Work Order ID 129121

Item Name: Baggage Compartment Protector Wall

DART SERVICE INSTRUCTION

TO AMEND INSTALLATION INSTRUCTIONS IIN-D407-781-2 REV. A OR LATER APPROVED REVISION
AND INSTRUCTIONS FOR CONTINUED AIRWORTHINESS ICA-D407-781 REV. 3 OR LATER REVISION

**FIGURE 1 - D3879-1 BAGGAGE COMPARTMENT WALL
PROTECTOR - ALTERNATE INSTALLATION**

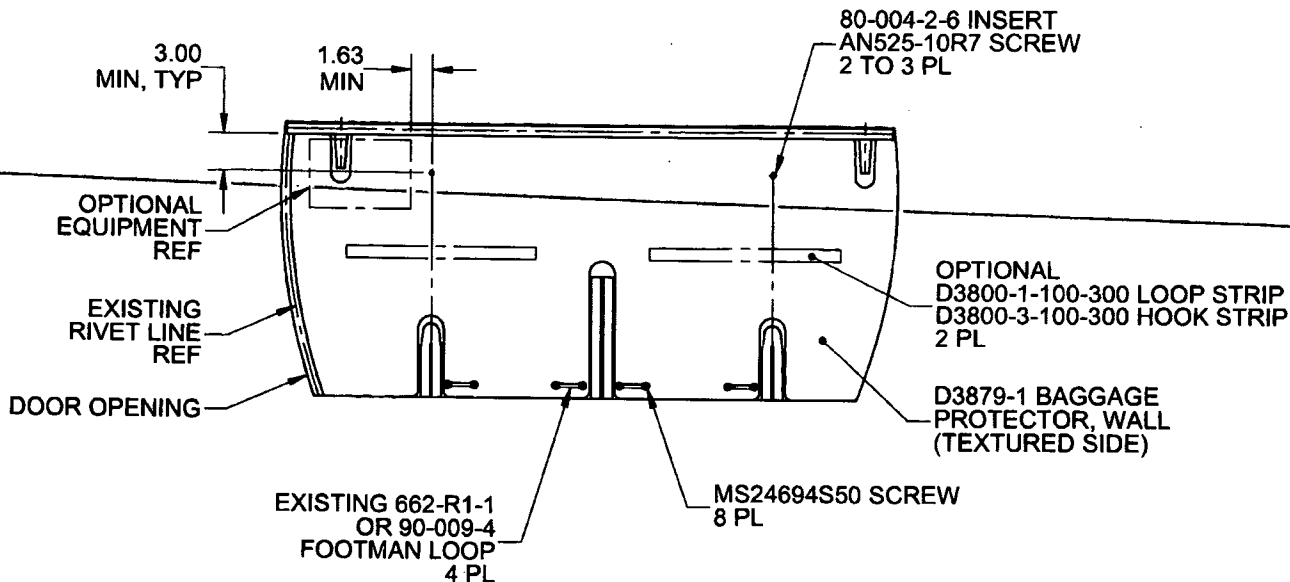
In some aircraft, the top portion of the D206-781-041 Baggage Compartment Wall Protector Kit cannot be installed as indicated in IIN-D407-781-2. The purpose of this DSI is to provide an alternate mounting method to fasten the top portion of the D206-781-041 Baggage Compartment Wall Protector Kit.

It is acceptable to replace qty(2) D3930-1 Clips with qty(2) 80-004-2-6 Inserts. Locate and mark location of the two attachment holes on the baggage compartment wall as shown in Figure 1 of this service instruction. Install 80-004-2-6 Inserts at the marked locations in accordance with Section 3-2-12 of BHT-206-SRM-1. It is acceptable to trim the wall protectors to accommodate optional equipment or transfer attachment holes to the wall protector and install the optional equipment on top of the wall protector with longer fasteners.

Amend the D206-781-041 Baggage Compartment Wall Protector Kit parts list as follows:

Qty -061	Qty -031	Qty -041	Part Number	Description
X			D206-781-061	BAGGAGE COMPARTMENT PROTECTOR KIT (FLOOR AND WALL)
1	X		D206-781-031	BAGGAGE COMPARTMENT FLOOR PROTECTOR KIT
1		X	D206-781-041	BAGGAGE COMPARTMENT WALL PROTECTOR KIT
		2	AN525-10R7	SCREW
		2	80-004-2-6	INSERT
